STATUS CODE DESCRIPTION  
**ISSUED FOR FURTHER INFORMATION**

PROJECT  
**ADAMSTOWN STATION BLOCK G**

DRAWING  
**GENERAL ARRANGEMENT - LEVEL 01 - FIRST FLOOR PLAN**

GA - 01 - FIRST FLOOR - PLANNING  
1 : 200

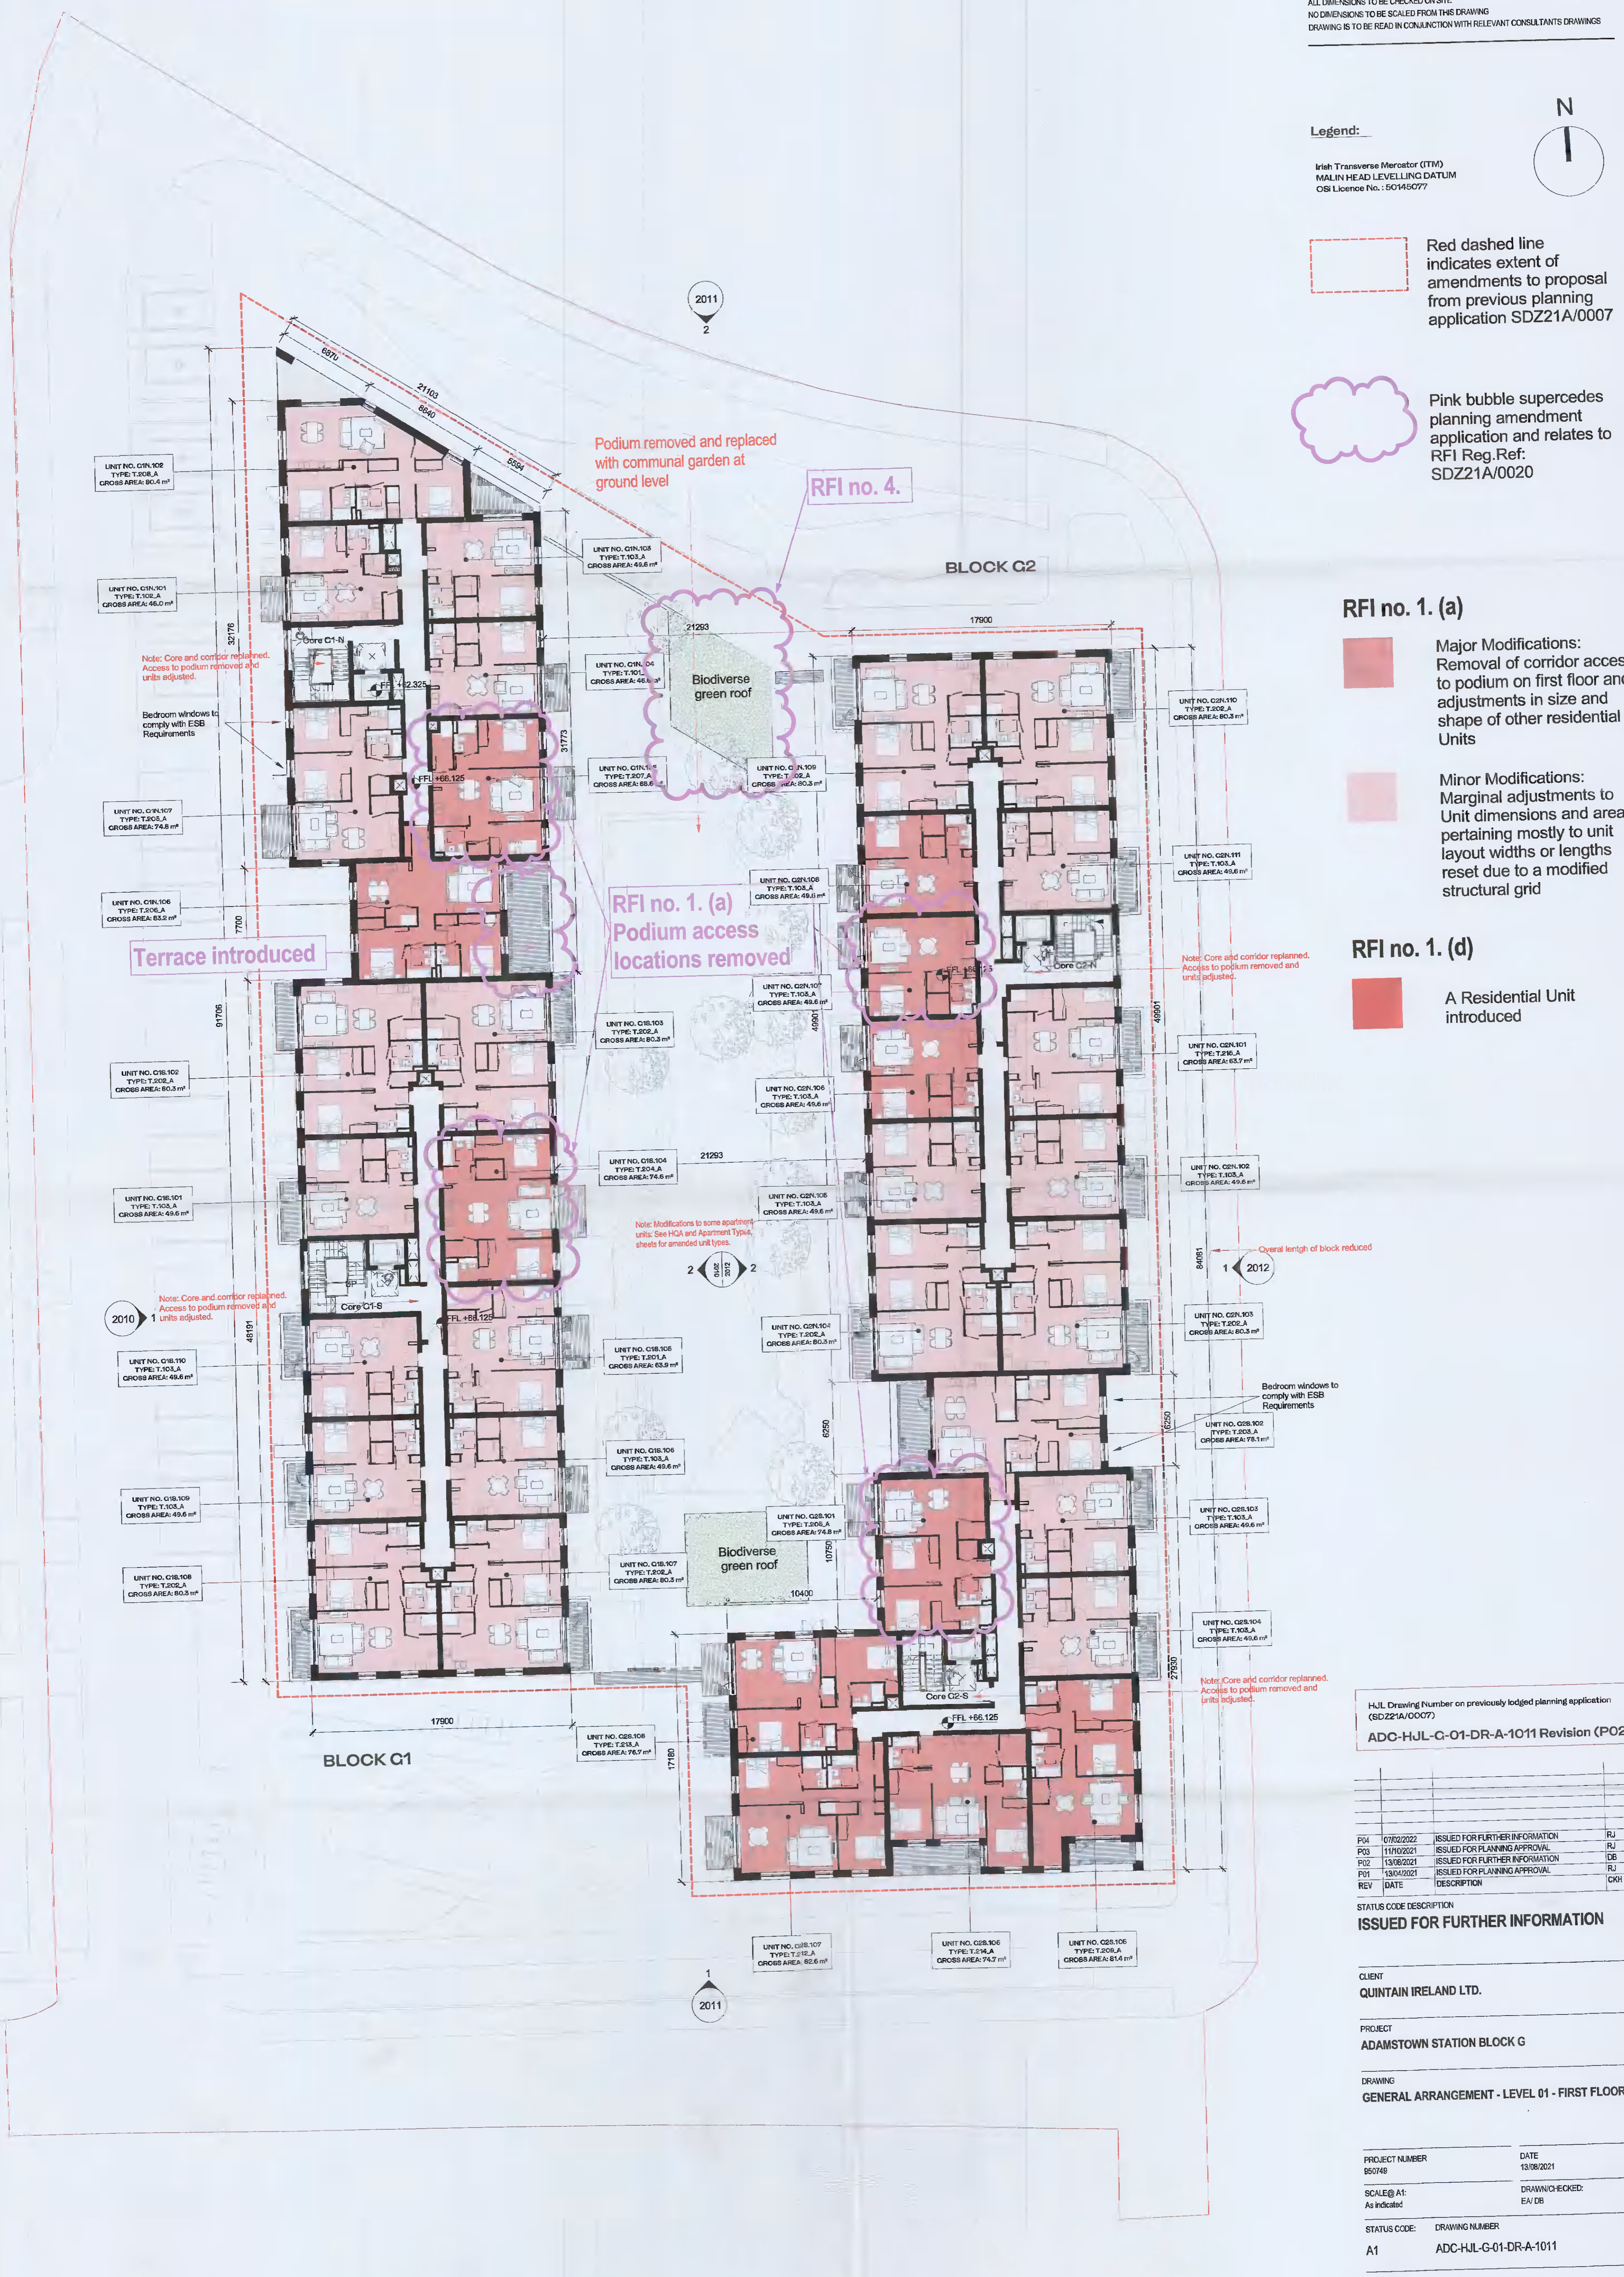
**RFI no. 1. (a)**

Major Modifications: Removal of corridor access to podium on first floor and adjustments in size and shape of other residential Units

Minor Modifications: Marginal adjustments to Unit dimensions and areas, pertaining mostly to unit layout widths or lengths reset due to a modified structural grid

**RFI no. 1. (d)**

A Residential Unit introduced
